APPENDIX C8:
Comments and Responses Report

KOTULO TSATSI ENERGY PV1, NEAR KENHARDT, NORTHERN CAPE PROVINCE (DEA Ref.no.: 14/12/16/3/3/2/2027)

COMMENTS AND RESPONSES REPORT

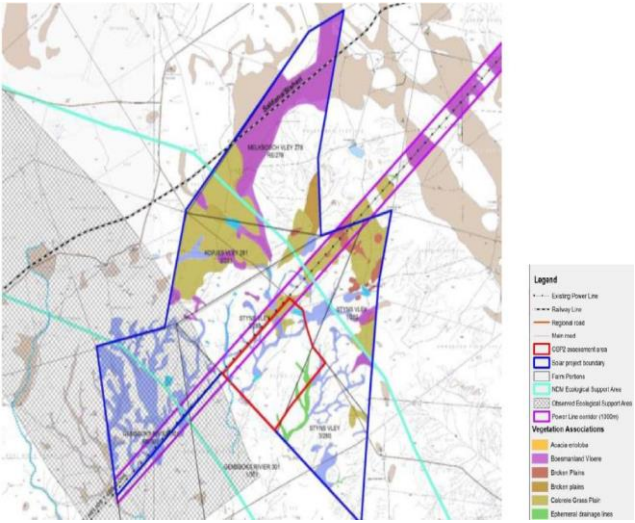
NO.	COMMENT	RAISED BY	RESPONSE
	<p>(estimated 10 to 15 birds) and Cape vulture (CV) of which single birds only have been seen. The official conservation status of the WBV in South Africa is "critically endangered" and the CV and LFV is "endangered". Vulture populations of all species have plummeted over the past 40 to 50 years, in some cases by as much as 85% (Botha et al 2017).</p> <p>The vultures in the Brandvlei area were first noticed towards the end of 2019. The highest number counted together at a single roosting site was 130 in February 2021 near the application area. Vultures forage over large areas and often in smaller groups so an exact number will be difficult to determine. The Brandvlei area is in the grip of a long drought and as a result high mortality amongst livestock and wildlife were the likely drawcard that brought the vultures to the area (Van der Merwe 2021).</p> <p>Van der Merwe counted 102 vultures at the end of February 2021 on the pylons right in the middle of the Kotulo Tsatsi Solar Reserve, please refer to Figure 1 in this regard. As such the development area proposed for PV1 and the associated infrastructure like transmission lines to the Eskom substation will negatively affect these birds directly.</p>		<p>Aries-Helios line from photographs in February 2021 and these observations of three red data species of vultures were included in the avifauna report (Page 27) for PV1. Up to that point there was nothing published on the presence of vultures in the area.</p> <ul style="list-style-type: none"> • The avifaunal specialist recommends that the Developer implement a 12-month post-construction monitoring programme to assess the mortality of birds in the solar farm, through direct observation and carcass searches, which is in line with the requirements of a Regime 3. This will assist in determining where individual specific mitigation measures are required to be implemented. • The original motivation for a Regime 2 assessment was based on prior knowledge of the site, as the site held few priority birds (bustards and the Martial Eagle). The only change to this is the arrival of the transient three species of vultures, in early 2021. These birds are new to the area as evidenced by the national bird atlas data (SABAP2) and the lack of previous vulture records from anywhere south of Kenhardt. These birds are also considered to be transient birds from Namibia (F van der Merwe, M Boorman pers. comm.). • However, their arrival (noted on page 27 of the avifauna report) does not change the conclusions on the impacts or the significance of the impacts, because PV facilities are not known, or expected to, negatively impact these red data species other than a small reduction in foraging habitat (see more below). • The reference to the 3 vulture species as contained in the Avifauna Assessment has been included in Chapter 7 for completeness. • The avifauna assessment did not assess the impact of grid connection infrastructure as this infrastructure has been previously authorised, and is not part of the scope for the change in generation technology from CSP to PV. • PV installations are among the most benign of all renewable energy sources. They have no moving parts for birds to collide with and have very low reflective surfaces compared with CSP trough and tower technology. Only two minor issues have been associated with avian fatalities at PV sites:

NO.	COMMENT	RAISED BY	RESPONSE
	 <p data-bbox="226 662 929 726">Figure 1: Van der Merwe vulture count of 102 birds on pylons in February 2021; position in circled area</p> <p data-bbox="226 767 929 1045">As per BirdLife SA the critically endangered WBV has declined severely in parts of its range. Overall, it is suspected to have undergone a very rapid decline owing to habitat loss and conversion to agro-pastoral systems, declines in wild ungulate populations, hunting for trade, persecution, collisions and poisoning. These declines are likely to continue into the future. Recently published data suggests these declines are even more serious than previously thought.</p> <p data-bbox="226 1050 929 1257">As per BirdLife SA the endangered LFV; only a small, very rapidly declining population remains, owing primarily to poisoning and persecution, as well as ecosystem alterations. Recently published data suggests that the population in Africa is declining extremely rapidly, and future population assessments may lead to further uplisting.</p> <p data-bbox="226 1262 929 1361">As per BirdLife SA the endangered CV population is declining rapidly, however, recent increases in parts of its South African range mean declines are not thought to be sufficiently strong</p>		<ul style="list-style-type: none"> <li data-bbox="1245 240 2134 300">• (i) double security fences where birds may be come trapped and unable to take off in South Africa (Visser et al. 2019), and <li data-bbox="1245 304 2134 432">• (ii) possible “Lake Effect” in which panels placed too close together may appear as a continuous shiny surface and mistaken for a water body that birds may try to land on. This has not been encountered in South Africa and is more of a theoretical possibility. <li data-bbox="1245 472 2134 663">• As avian specialists with a long track record of conservation related activities (RES is the first author on the Namibian Red Data book of birds: 2015) are very aware of the dire conservation status of the three species of vultures now present on the Aries- Helios transmission lines, north of Brandvlei. They should be protected from the poisoning (as clearly stated in the report). <li data-bbox="1245 668 2134 924">• The mention of the vulture restaurant by the game farm does, in principle, have merit, as well-managed facilities have many benefits. However, such a restaurant must be well managed, operated throughout the year and ideally be registered with Birdlife South Africa, before it can go ahead. The provision of some meat from game farming at only time of year (e.g. after the hunting season) does not constitute a vulture restaurant. As this is not yet established, it cannot be considered in this assessment. <li data-bbox="1245 928 2134 1222">• We would also need to ascertain exactly where the Leopont game farm is located (no location was given). This becomes important because the Aries-Helios 400 kV line is known to kill large numbers of large birds (own studies over 50 km). If this line and the proposed 765 kV line occur on the flight line to the restaurant then it may kill the vultures through direct impact if they are not mitigated (lines adjacent and pylons staggered, and diverters affixed to the earth wire). The impacts associated with such a facility must be identified and assessed appropriately prior to any implementation to avoid impact to the birds. <p data-bbox="1245 1257 2134 1316">In conclusion the specialist can find no basis for the statement that the study is “critically flawed” because</p> <ul style="list-style-type: none"> <li data-bbox="1245 1321 2134 1350">(i) The specialist is fully aware of the presence of threatened vultures,

NO.	COMMENT	RAISED BY	RESPONSE
	<p>to warrant listing as Critically Endangered. Its small population is likely to continue declining unless ongoing conservation efforts, including public awareness programmes and supplementary feeding, as well as efforts to reduce the threat from powerlines, are successful (Collar and Stuart 1985).</p> <p>Leopont the owners of a game farm with a hunting lodge have been involved in eco-tourism and conservation in the area for many years. The owners regard the conservation of these vultures of utmost importance and the existence of a Solar Reserve with new transmission infrastructure and approved CSP components will be lethal to these critically endangered and endangered species. These species require protection at all costs.</p> <p>As such Leopont is in the process of establishing a vulture restaurant. A vulture restaurant is a stationary regularly supplied feeding station for vultures. Instead of vultures having to search for food over a very large area and thus visiting many farms and be subject to many threats including being persecuted, poisoned, colliding with man-made structures such as fences and power lines and drowning in farm reservoirs, a vulture restaurant could keep them relatively safe in a smaller area. All over the world in farming areas vulture restaurants are deemed good for the safety and conservation of vultures (Brink et al 2020). They may also help to mitigate farmer and vulture conflict.</p> <p>The Leopond farms northwest of Brandvlei in an area where large numbers of vultures have been observed to roost on power line pylons. These pylons are of a design that provide relatively safe roosting sites to vultures. Establishing a vulture</p>		<p>(ii) A regime 2 avian assessment was not triggered because the arrival of the vultures was not known at the time of the assessment report. However, this was noted on p27 of our avian report, and does not alter the findings.</p> <p>(iii) This would not change the conclusions of our report given that PV technology is so benign to large bird species that we do not predict any impacts other than a loss of foraging habitat.</p>

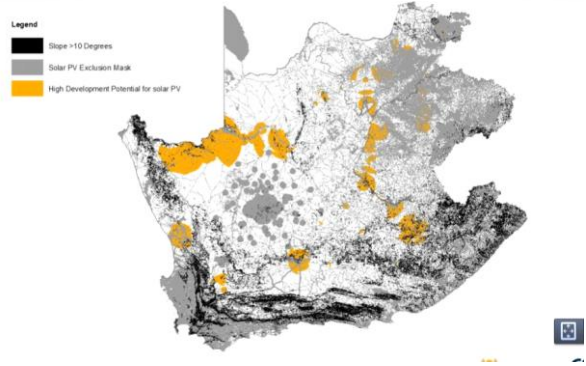
NO.	COMMENT	RAISED BY	RESPONSE
	<p>potential to unlock further conservation and eco-tourism development not assessed or considered in the EIA Report or specialist reports.</p> <p>The above strengthens the previous Leopont objections and appeals since the initial CSP application regarding the proposed development, construction and operation of a Solar Reserve in this preselected sensitive location. The current DEFF case officer should take note and investigate the application history of this Solar Reserve (larger site) and the previous rejection of the studies by DEA at the time due to a lack of site alternative investigations and the location of to the Namaqua District Municipal ESA (find the previous DEA letter attached under Appendix 1).</p> 		<p>The consideration of ecotourism and conservation/protected areas in relations to the proposed Kotulo Tstatsi Energy PV1 is therefore based on formally recognised conservation areas and available information for the area.</p> <p>The Namakwa Bioregional Plan Draft 1 was published in 2010 by the Namakwa District Municipality however, updated CBA data has been subsequently published by the Northern Cape DARD&LD which provides objectives for Critical Biodiversity Areas, Ecological Support Areas (ESA) and Other Natural Areas. Based on this latest data for the Northern Cape it has been determined in the Ecology Assessment (Appendix D of the EIA) development envelope of Kotulo Tsatsi PV1 is located within Other Natural Areas.</p> <p>The study area lies entirely within the Bushmanland Basin Shrubland vegetation type which is classified as Least Threatened. The site lies entirely outside of any Critical Biodiversity Areas (CBAs) or Ecological Support Areas (ESAs) and does not fall within any National or Provincial Protected Area Expansion Strategy Focus Area (PAES) and as such is not currently considered significant for meeting conservation targets, either at the national level or within the province. Therefore, there are no potential impacts associated with the proposed development that are considered to be of high significance and which cannot be mitigated to an acceptable level. These findings are confirmed/supported by DFFE: Directorate Biodiversity Conservation.</p> <p>The proposed Kotulo Tsatsi Energy PV1 development will be located on a site that has been previously authorised for CSP infrastructure, with a much larger footprint. This assessment undertaken for a change in the generation technology, which will also result in a reduced footprint for that which has been previously authorised. Site-specific studies and assessments have delineated areas of sensitivity, and the optimised layout for Kotulo Tsatsi Energy PV1 avoids these sensitivities.</p>

NO.	COMMENT	RAISED BY	RESPONSE
	<p>Figure 1: Savannah Source Map ; NDM ESA (macro regional corridor) between turquoise lines and “observed” during the previous EIA as hashed grey</p> <p>DEFF should take note how this regional corridor that runs through the middle of the site was initially ignored when the 55 000 ha site was selected for the development of a Solar reserve only to be changed as an observed corridor. Again it emphasis our reasoning that the natural environment did not receive priority in site selection, and the EIA is just an administrative process that the applicant is going through. The consultants at a very late stage became creative through micro analysis and “moved” the ESA south, to conveniently exclude the preferred development footprint from the corridor and to unlocking the potential for further solar farm develop in the Solar reserve area. Now the vultures have been observed right in the middle of this corridor isn't it ironic?</p>		<p>For the previously authorised projects on the project site, the ESA was ultimately modelled and defined by field work conducted by recognised specialists, and that this was accepted by DEA, DEA's biodiversity directorate as well as DENC. Current data for the Northern Cape CBAs excludes this ESA corridor all together, but the applicant and landowner have for the purpose of this PV application chosen to adhere to the exclusion of this defined area from the development footprint. Queries that were previously raised by DEA have been systematically evaluated and resolved, and ultimately the DEA was confident in the findings of the previous EIAs and authorised a large scale project on this site.</p>
